WARRANTY CAMPAIGN

Campaign no.: 2012-0001

Subject: **Spyder™ RS – Lateral Support Bracket Modification**

No. **2012-1**

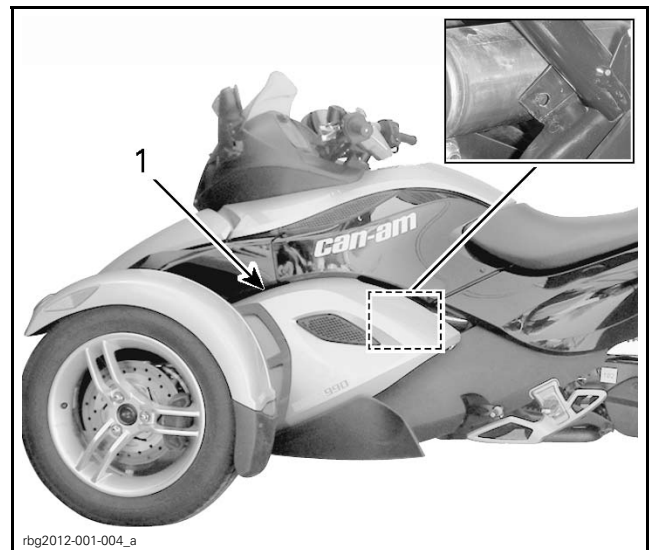
PROBLEM

On some units, a bracket on the LH lateral support may contact an exhaust head pipe.

SOLUTION

Inspect the bracket area. Bend the bracket if necessary.

1. Middle side panel (remove)

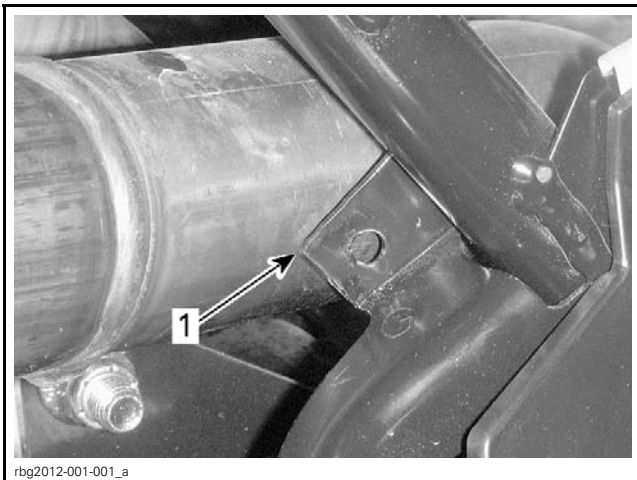
1. Remove the LH middle side panel.

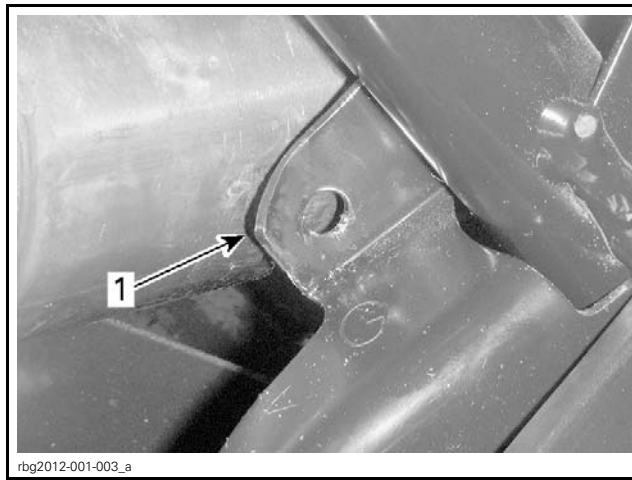
2. Verify the clearance between the bracket and exhaust pipe.

1. Minimum 7mm (1/4 in)

1. Bent bracket - minimum 7mm (1/4 in)

BRACKET INSPECTION	
At least 7 mm (1/4 in) clearance	No action required
Less than 7 mm (1/4 in) clearance	Modify bracket as follows

3. Bend bracket

3.1 Protect bracket and pipe finish with a rag.

3.2 Bend using suitable pliers
